MSPM0L1105 Dev Board

Sheet: /
File: MSPM0L1105_dev_board.kicad_sch

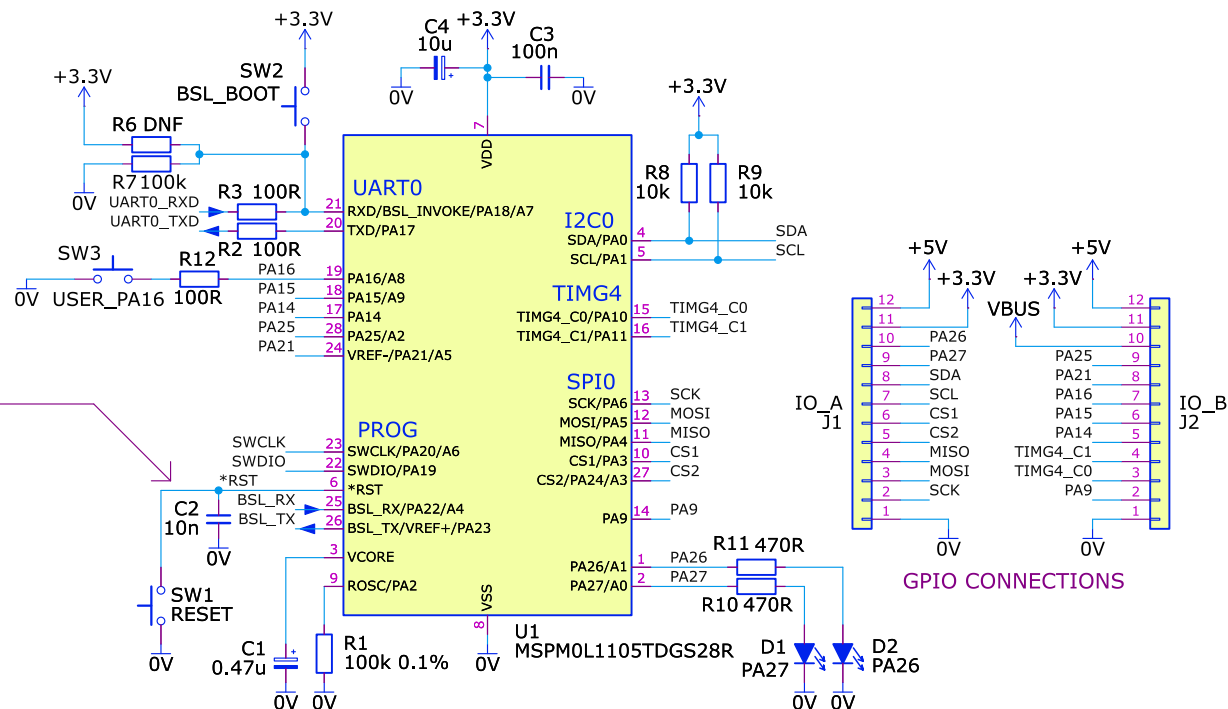
Rev 1 PCB is missing a 47k pull-up resistor from the *RST pin (pin 6) to +3.3V.
To make the board work, patch a 47k resistor onto the board underside.
